PROPOSED MODIFIED EXPRESS TERMS
FOR
BUILDING STANDARDS
OF THE
CALIFORNIA STATE LANDS COMMISSION

REGARDING AMENDMENTS TO
CHAPTER 31F, MARINE OIL TERMINALS
2007 CALIFORNIA CODE OF REGULATIONS, TITLE 24, PART 2

The CSLC has proposed changes to ninety-one (91) sections during the first comment period from 12/26/08 through 02/24/09. Pursuant to the comments received, changes were made to seven (7) sections of those originally proposed express terms. The second comment period was observed from 09/16/09 through 09/30/09 and no comments were received during this period. However, late comments are addressed in the Final Statement of Reasons.

FIGURE 31F-2-1

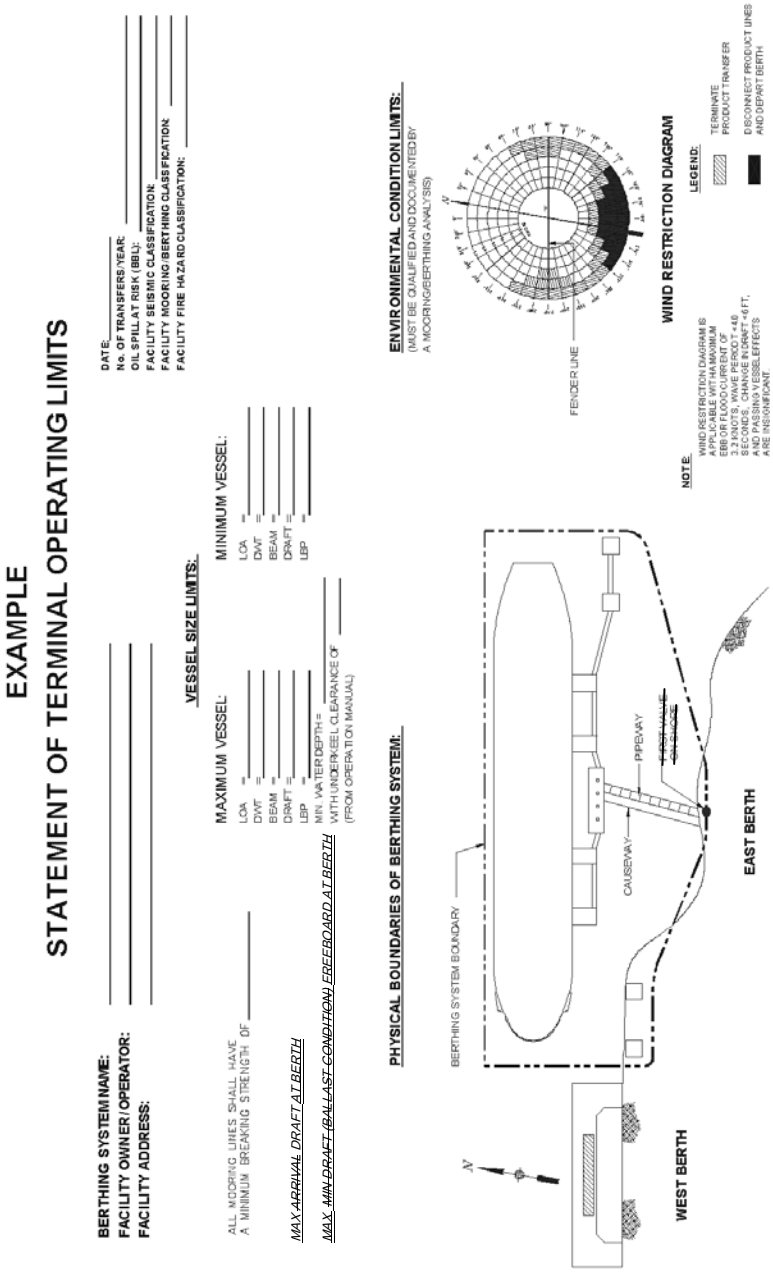
16. *3102F.3.6.1 Terminal Operating Limits. Figure 31F-2-1*

FIGURE 31F-3-1 - DESIGN ACCELERATION RESPONSE SPECTRA FOR THE PORTS OF LOS ANGELES AND LONG BEACH, 475 YEAR RETURN PERIOD (5% Critical Damping)

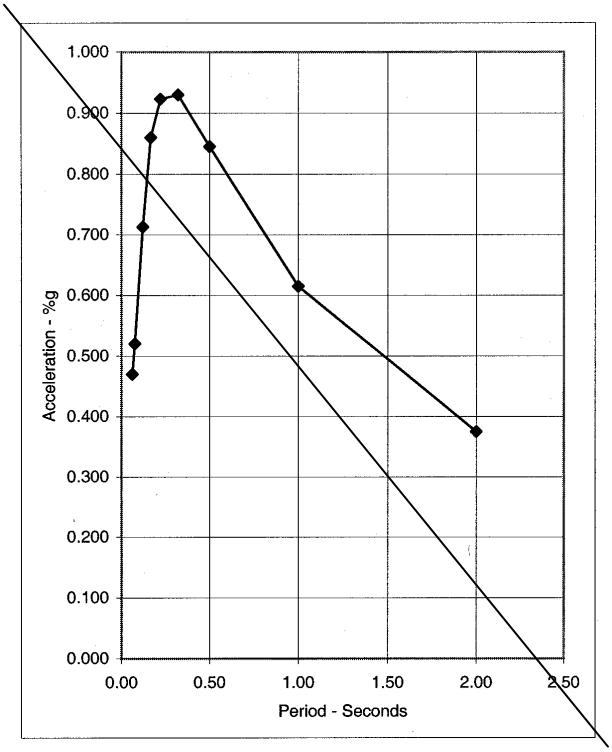
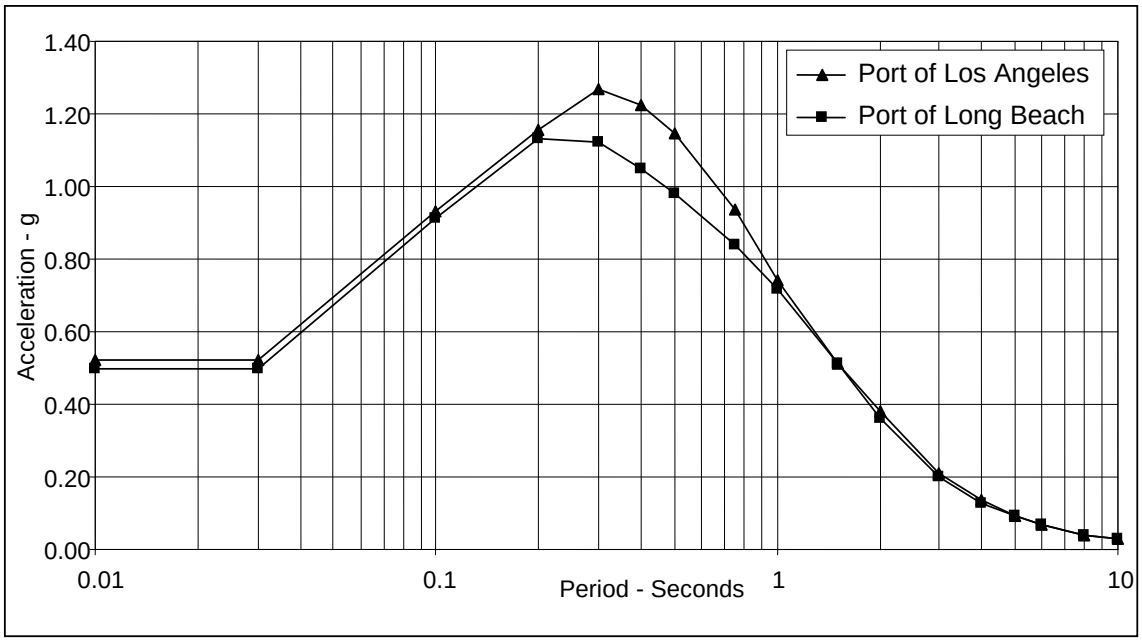
20. ***3103F.4.2.3 Earthquake Motions from Site-Specific Probabilistic Seismic Hazard Analyses. Figure 31F-3-1***

~~***Figure 31F-3-1 Response Spectra for the Ports of Los Angeles and Long Beach, 475 Year Return Period (5% Critical Damping)***~~

Figure 31F-4-4--Design Displacement Response Spectra

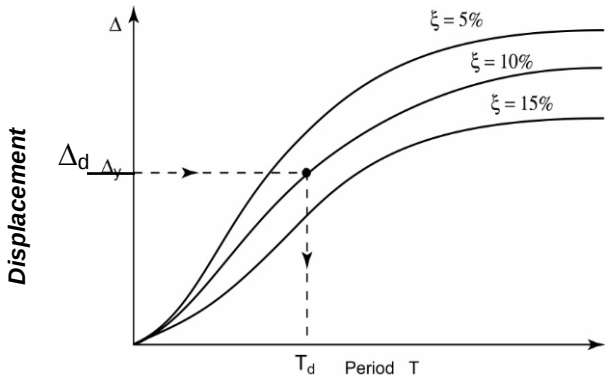
48. *3104F.2.3.2.5 Refined Analyses.*
